MONTICELLO NUCLEAR GENERATING PLANT
Docket No. 50-263 License No. DPR-22

Response to 12/14/76 Questions on
Single Recirculation Pump Operation

Revision 1 to License Amendment Request Dated September 7, 1976
Single Loop Operation

Figure 4-1. Decay Ratio Versus Power Curve for Two-Loop and Single-Loop Operation

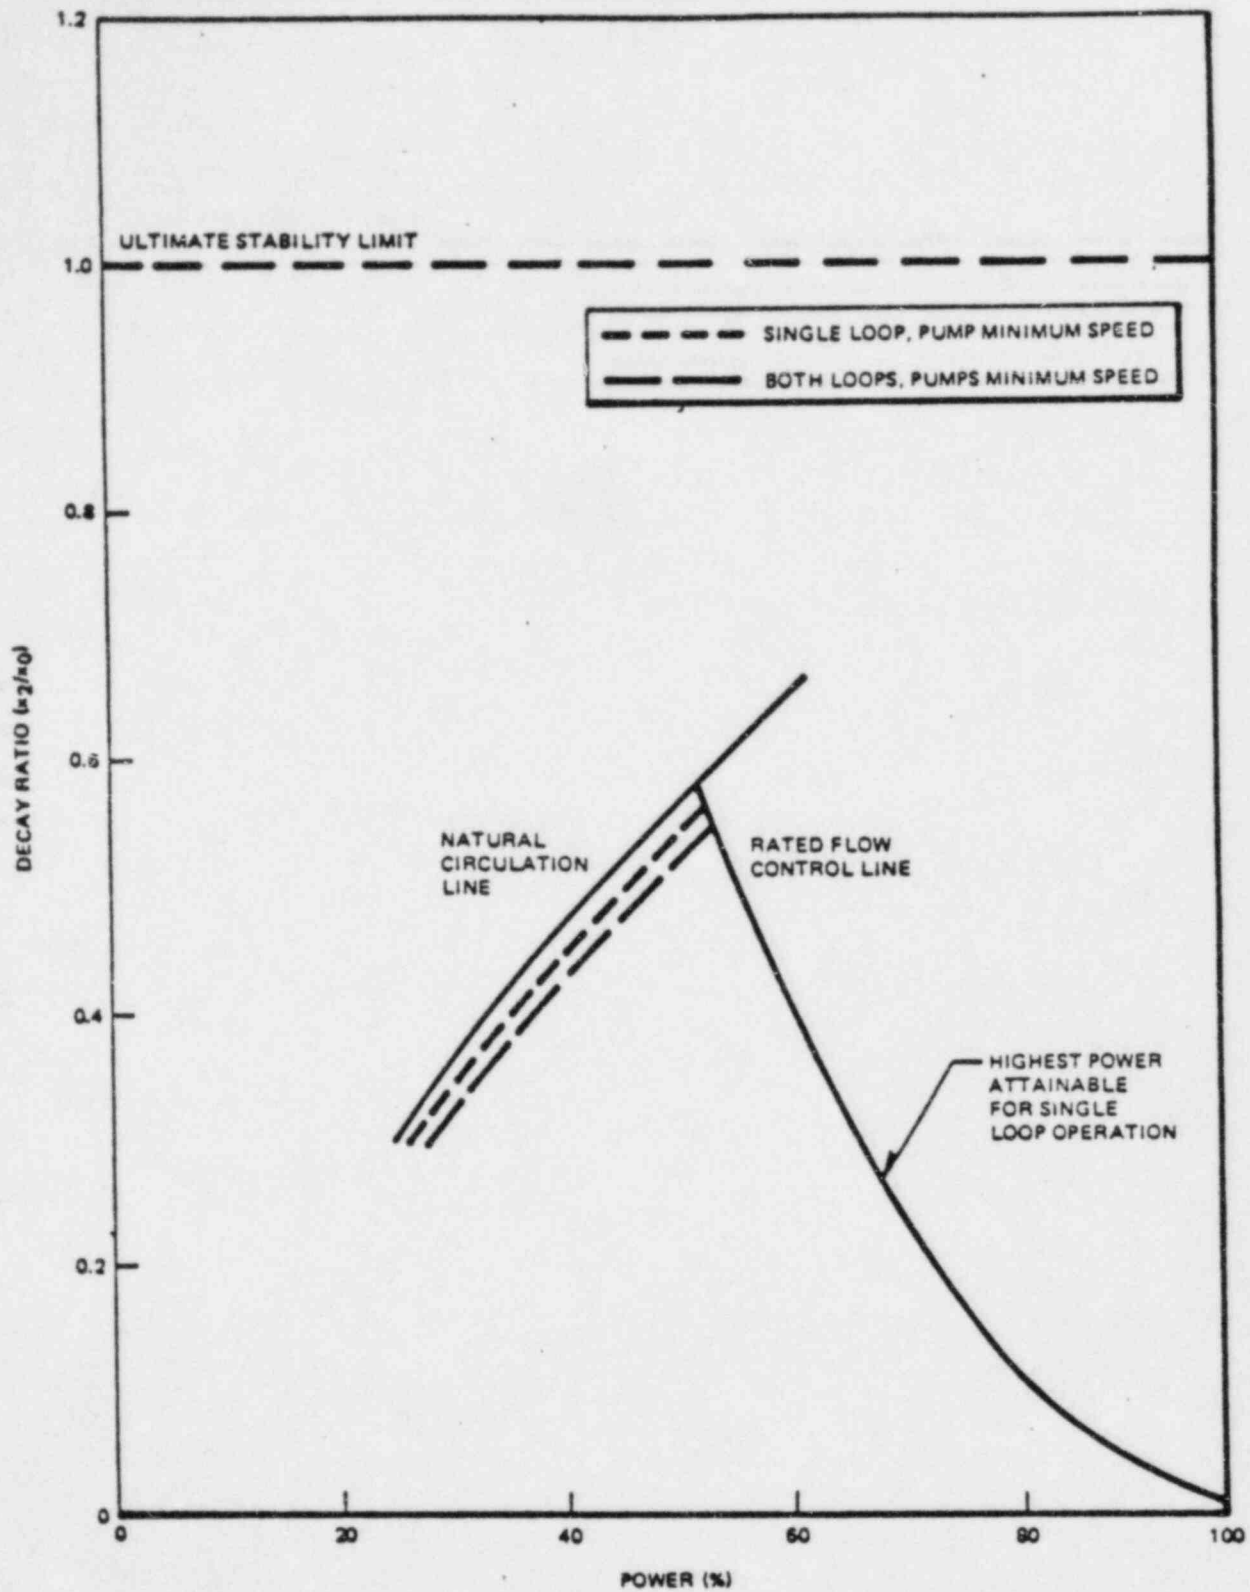
Figure 4-1 of the Monticello Nuclear Generating Plant Single Loop Operation Report, Exhibit C of our July 2, 1982 License Amendment Request, shows that with the loop operation to be used for single loop operation. Figure 6 of the Supplemental Reload License Application for Monticello Island 9 (Cycle 10), Exhibit C of our June 25, 1982 License Amendment Request, states that natural circulation was analyzed for Cycle 10 and found acceptable. Therefore, no specific stability analysis for single loop operation for Cycle 10 was necessary.
